Device TC1797
Marking/Step QS-AC
Package P/PG-BGA-416-10

01961AERRA

This Errata Sheet describes the deviations from the current user documentation.

FADC_TC.005 Equidistant multiple channel-timers

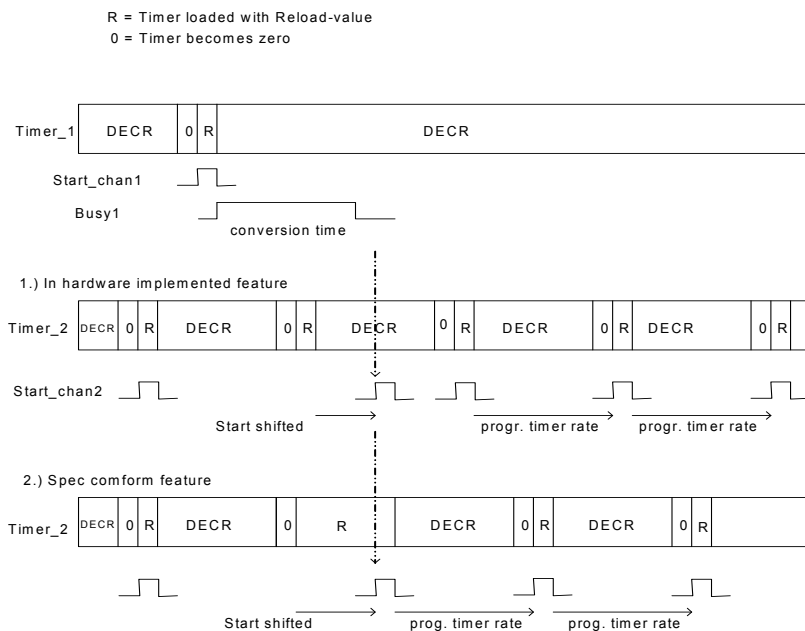
The description is an example for timer_1 and timer_2, but can also affect all other combinations of timers.

Timer_1 and Timer_2 are running with different reload-values. Both timers should start conversions with the requirement of equidistant timing.

The correct behavior would be a reload when the requested conversion (of channel_2) is started.

Therefore the start of conversion for channel_2 is delayed by maximum one conversion-time. After this delay it will be continued with equidistant conversion-starts. Please refer to the following figure.

Figure 2 The second frame starts in the same slot

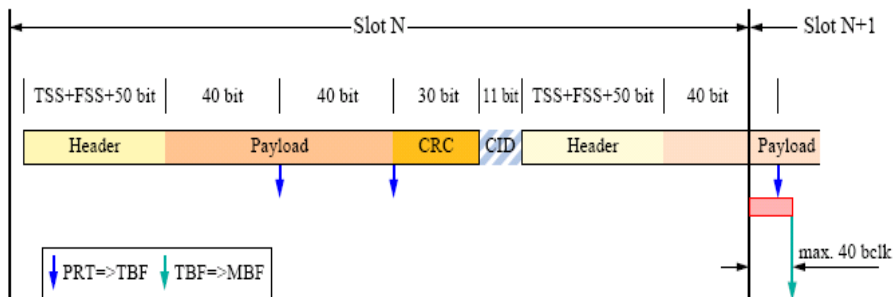
Scope:

The erratum is limited to cases where the complete header and a part of the payload of another frame is received in slot N.

The transfer of a received valid frame from TBF to MBF is initiated by the end of the actual slot. Execution is started not later than 40 bclk periods after the slot change. 40 bclk periods equate 10 bit times, when $\text{bclk}=40\text{MHz}$. Corruption of payload occurs when a transfer from PRT to TBF happens in the red marked time window between start of new slot and start of transfer from TBF to MBF.

Figure 3 Loss of Arbitration

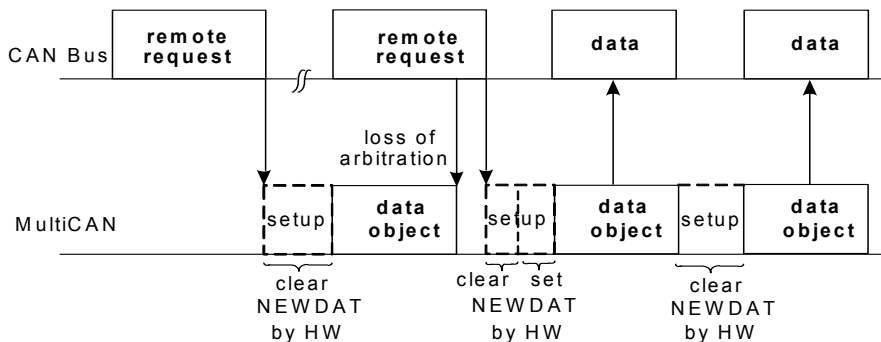
When the appropriate message object (data frame) triggered by the first remote frame wins the arbitration, it will be sent out and `NEWDAT` is not reset. This leads to an additional data frame, that will be sent by this message object (clearing `NEWDAT`).

There will, however, not be more data frames than there are corresponding remote requests.
